August 1986

# Final Environmental Impact Statement Canyon Uranium Mine

ENVIRONMENTAL IMPACT STATEMENT  
CANYON URANIUM MINING PROPOSAL  
COCONINO COUNTY, ARIZONA

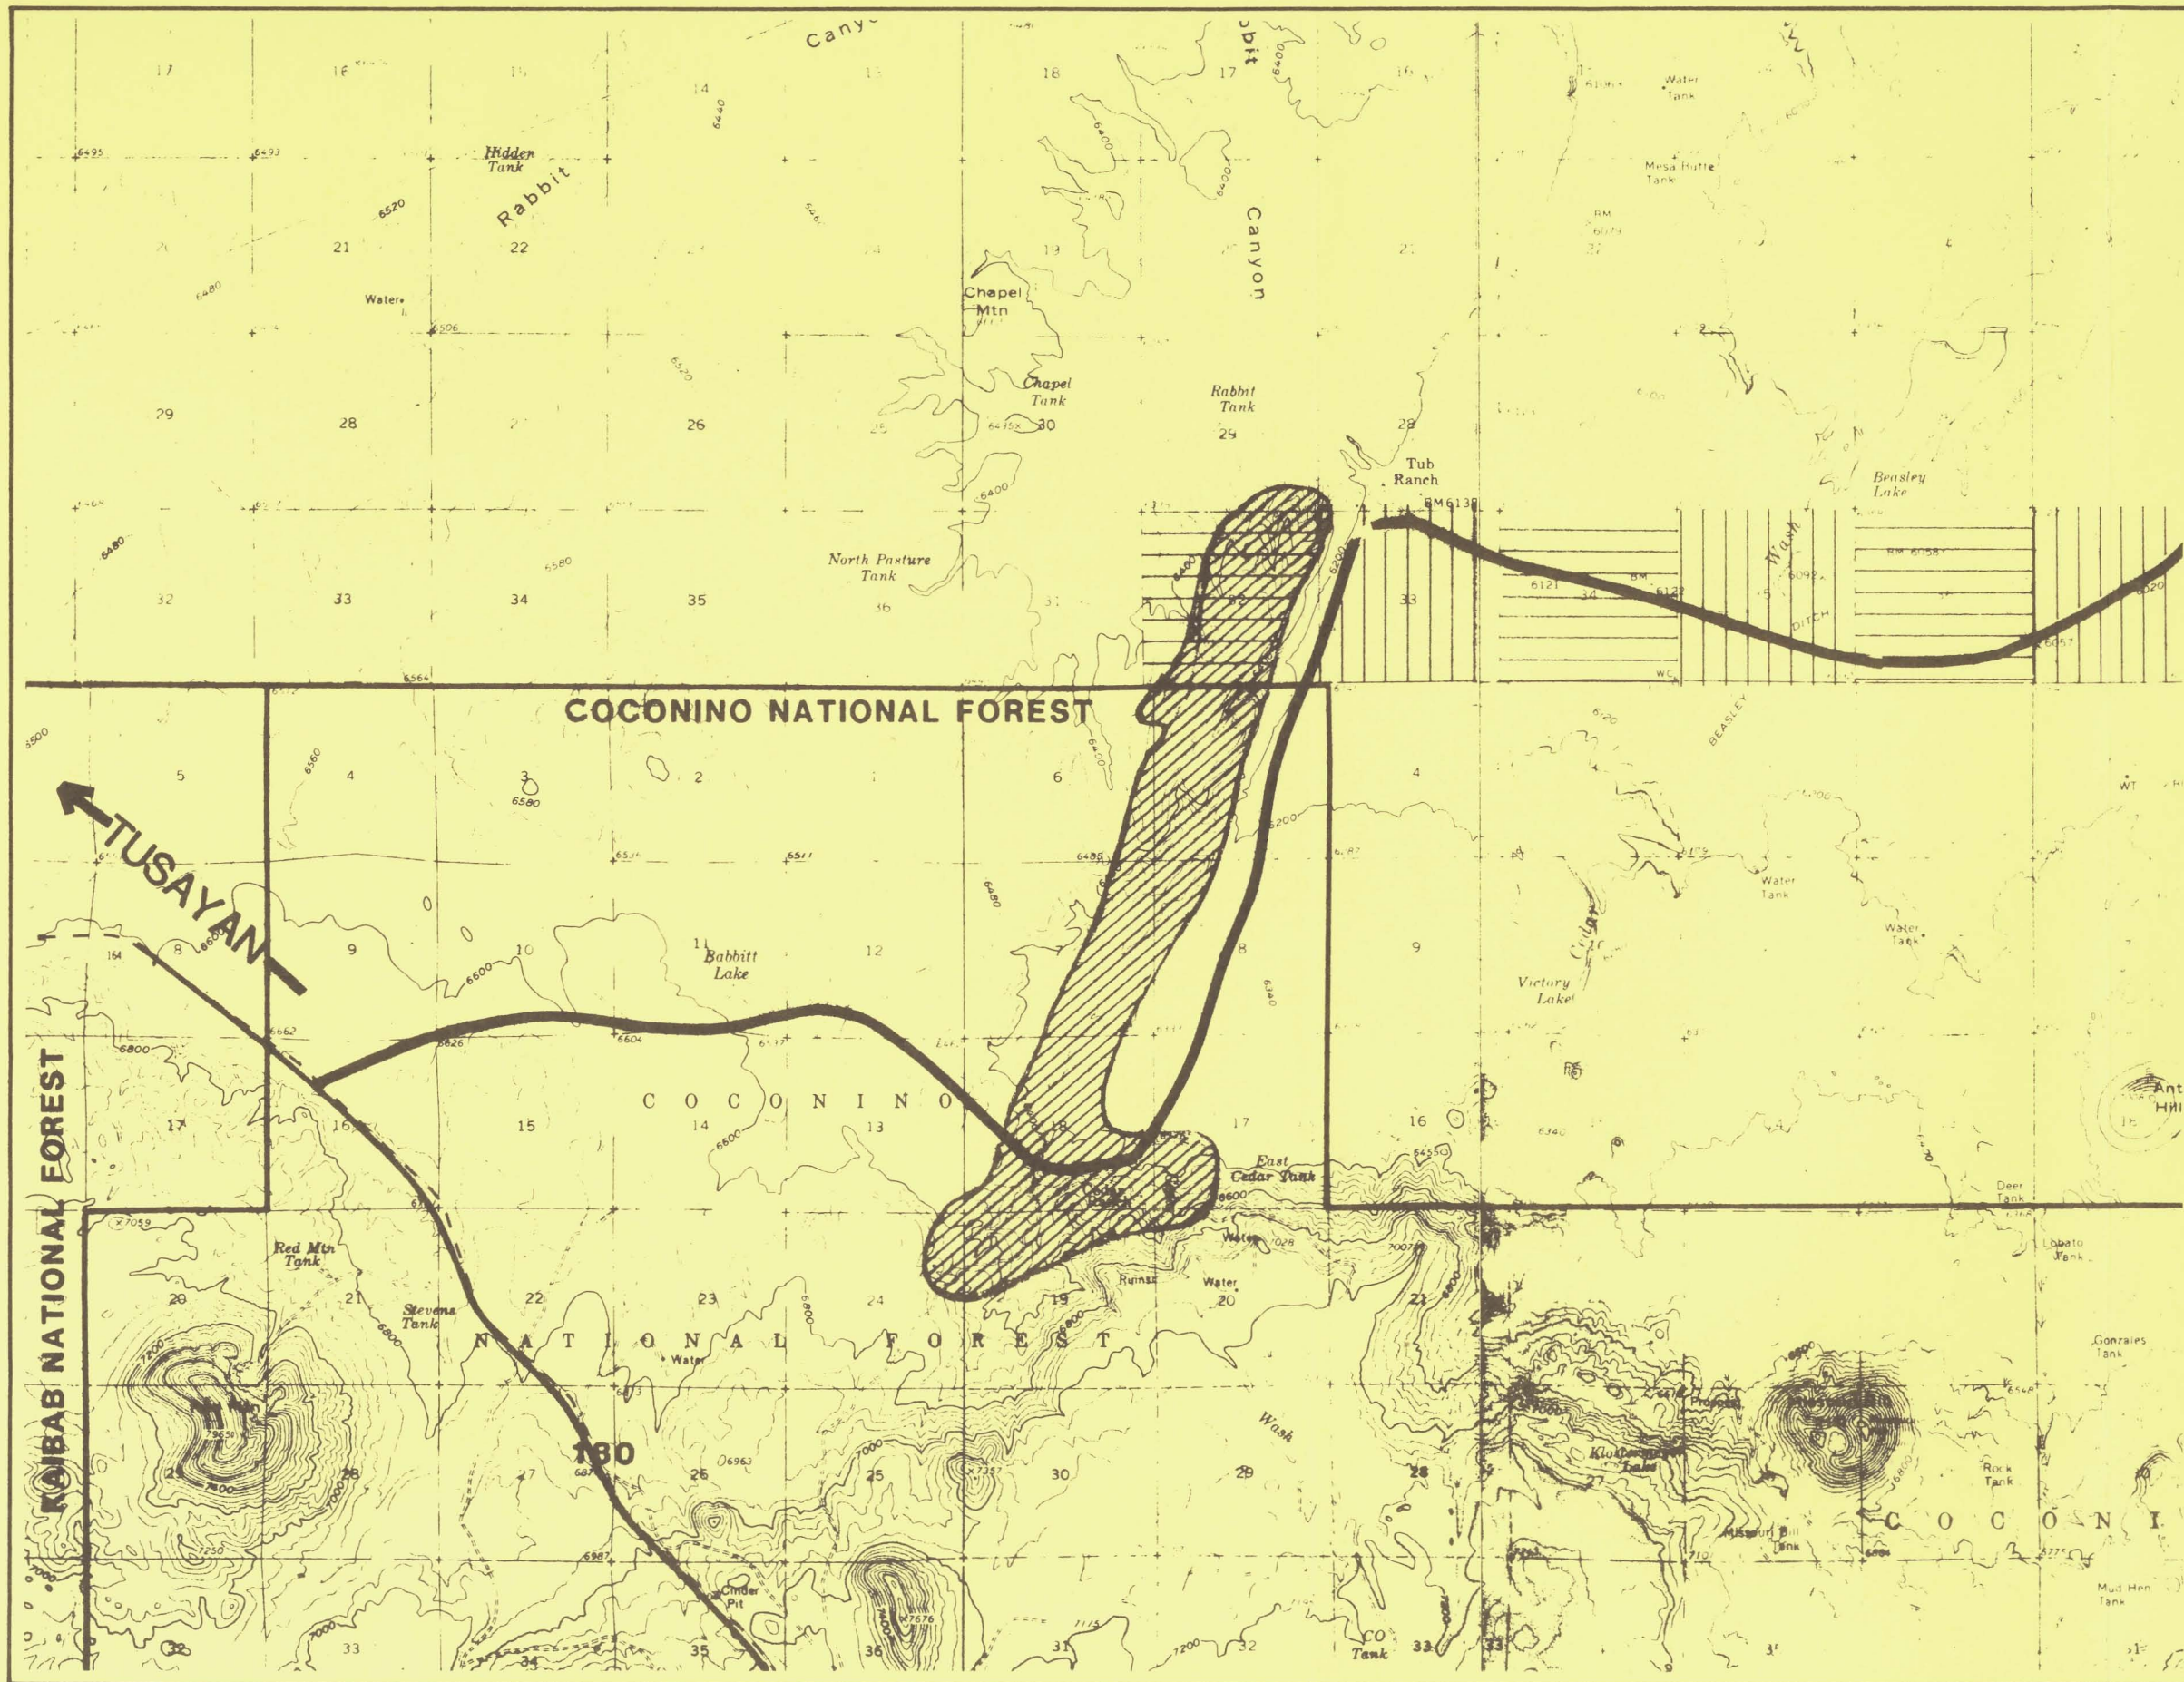
56-2 As for the haul route options- 1,2,3,4,5, & 7 are all bad choices because of their effect on wildlife. In addition, option 5 is a poor choice because of the unsightly new road off the Coconino Rim that it requires. But regardless of the haul route that is selected, the mine itself will be bad news for wildlife. Figure 3.3 shows the mine site right in the middle of a deer fawning area- one of only five such fawning areas in the region. Considering that there are thousands of other mining claims in the Grand Canyon area just waiting for this one to set a precedent, it may not be long before the only deer in the Kaibab National Forest is the one on the cover of your EIS.

As shown in Figure 2.2, both haul route options 1 and 2 use a portion of Forest Road 302 which passes within one mile of the East Rim Drive in the Grand Canyon National Park near Grandview. The forest vegetation in this particular area is fairly dense. At present, vehicle traffic on Forest Road 302 is inaudible to Park visitors along the East Rim Drive. Given the buffering effect of a dense forest canopy on noise and the anticipated minor increase in traffic noise from the ore trucks, the noise impacts of ore truck traffic upon Park visitors should be negligible, if any.
